工程指示 / 要求簡箋(E.I.)

工程指示編號：EI / 6457 / 23

工程名稱：將軍澳日出康城 11

工程項目：顧問上廠報告 (23/5-29/6) 精華版加完整版

Photo 9

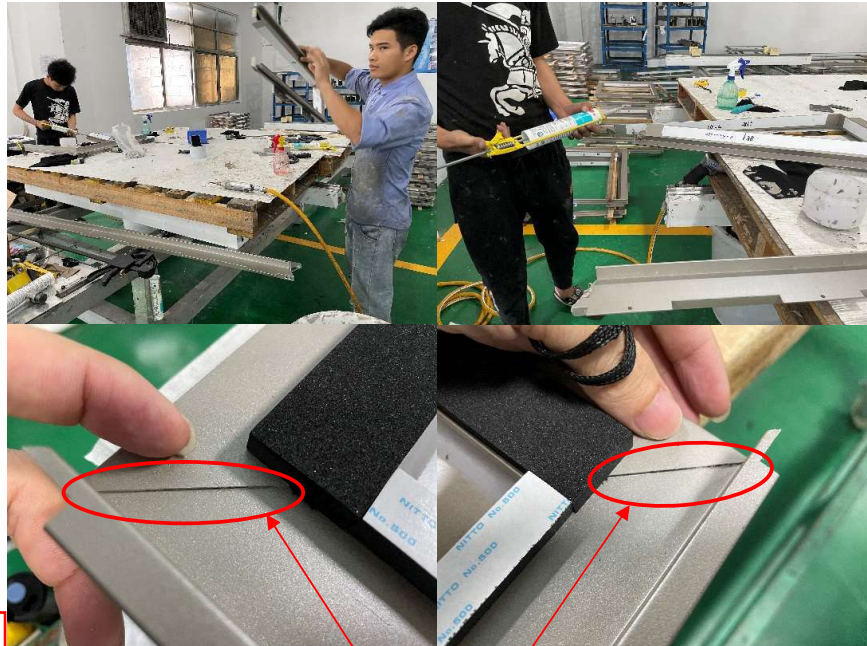
Description:
Fit-up assembly of glass wall Mullion and Transom for T3 22/F to 26/F Zone MO14

Action:
- MIDI is reminded to carry out the remedial works prior products delivery and to improve workmanship for future works

The splicing of two components is uneven

#1 找相同的鋁料,影夾角是一致的
